FOR PERCOLATION TESTING AND SITE EVALUATION

Re: Hogan / Pieprzak Residence
#2571 Wellworth Way
Building Addition

RE: PERCOLATION TEST RESULTS, A-527321

RE: Revised Percolation Certification Plan 2571 Wellworth Way, PC26025

AP 527321

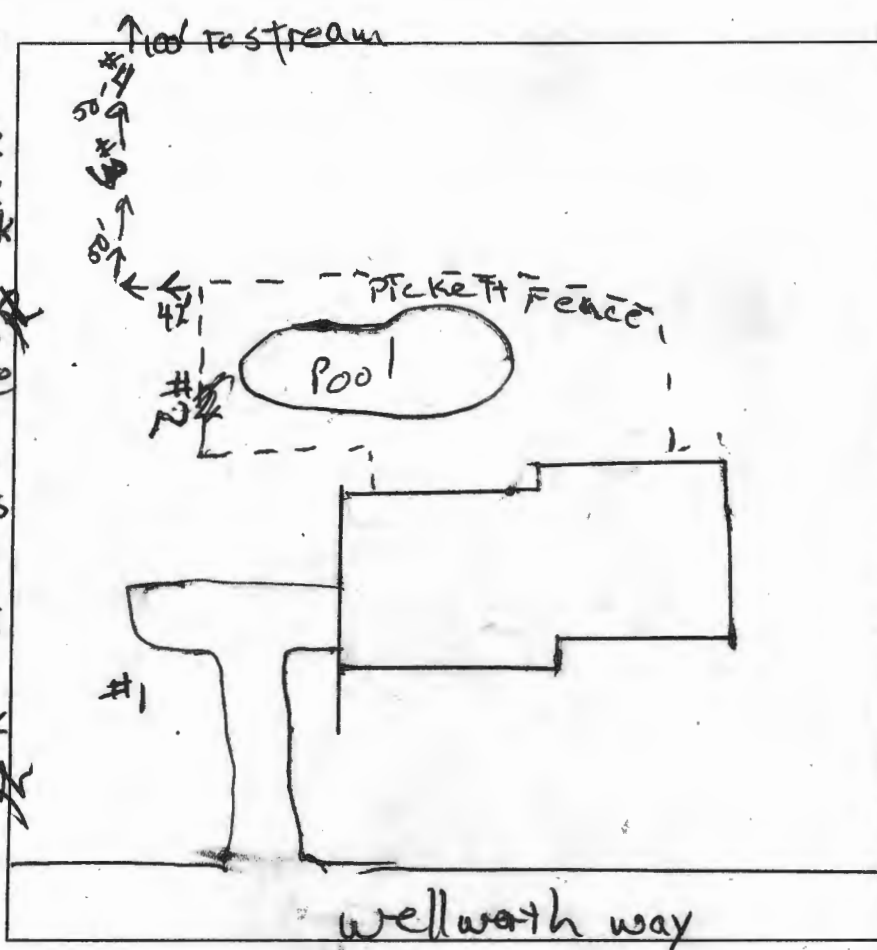
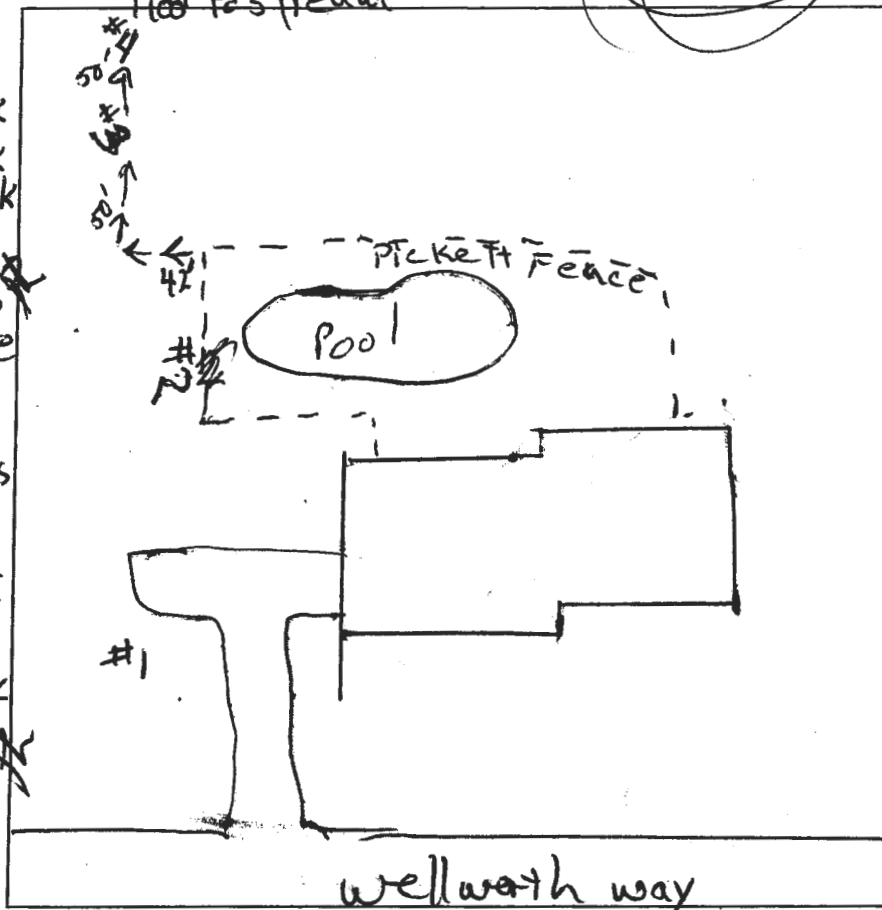
REMARKS #3, 3' deep to 8' 3-ft. thick vein grey mica schist & quartz, strongly cemented

All four test holes passed and were dug per plan. The onsite engineer, Bruce Burton, estimated the area represented by these tests to be at least 10,000 square feet (therefore, holes numbered 5 and 6 were not tested). The holes varied in depth from the top to the bottom of the easement. Testing of hole number 4 determined the seasonal water table to begin at approximately 9 feet by the presence of high moisture content and low chroma colors in the soil. An observation test hole (#1) was dug adjacent to the approximate location of the existing drywell. Soil conditions at test location 1 are considered satisfactory to 10' in depth. The subsoils described at the test locations are primarily micaceous, channery, fine loamy sands with moderate rock content. A 3-foot wide vein of strongly cemented mica schist and quartz was encountered at location 3. The vein dips 60% from horizontal in a westerly direction (290 degrees). Test hole 3 was completed to 11 feet depth immediately downslope of this indurate structure. The proposed septic easement which lies along the north property boundary includes areas that are adjacent to slopes greater than 25%. This issue has been addressed by approval of a Request for Variance (submitted in August).
